SUBJECT: OBSERVATIONAL SITE VISIT AT GUNNISON DISPOSAL SITE

OBSERVATIONAL SITE VISIT AT GUNNISON DISPOSAL SITE DATED
SEPTEMBER 20, 2022

Report: WM-00061/2022-001

Facility: Gunnison Disposal Site

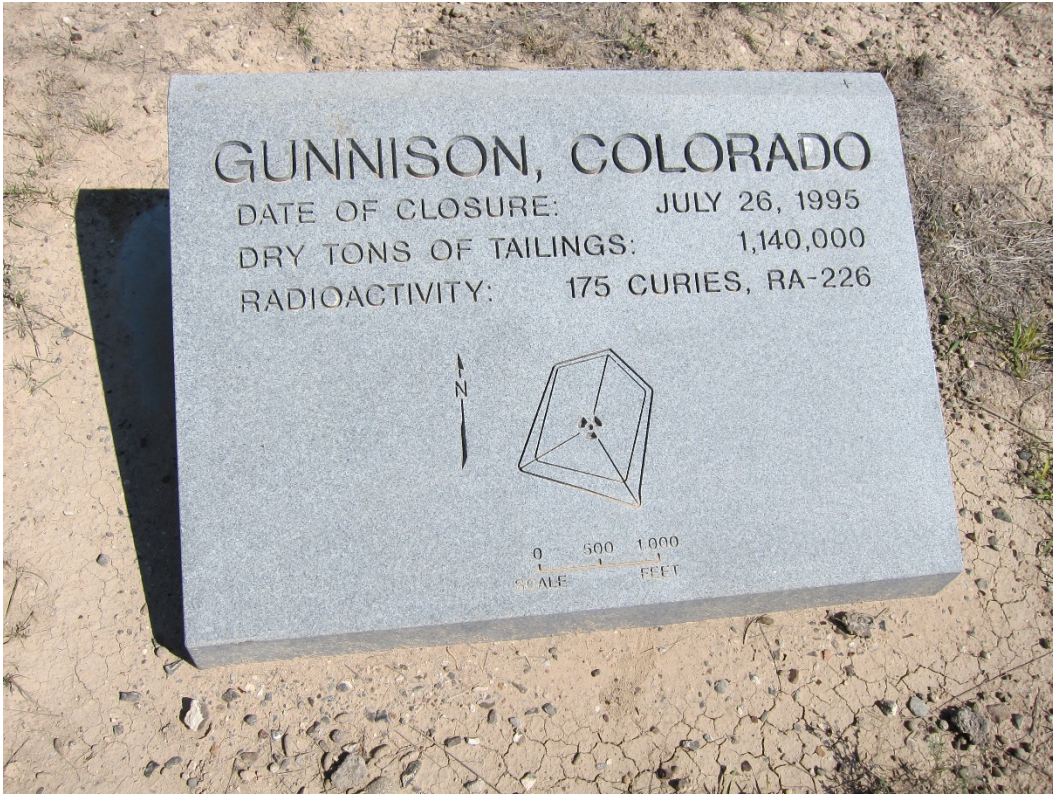
The inspector observed that the disposal cell and surrounding apron and diversion trenches appeared to be in excellent condition. No erosion or slumping was observed on or around the cell. Although minor amounts of vegetation were observed on the cell cover and apron, the vegetation of concern was recently treated by DOE representatives (Figures 4 and 5). Prairie dog holes were observed near the main gate and other locations, but DOE staff documented these features and planned to conduct follow up actions (Figure 6).
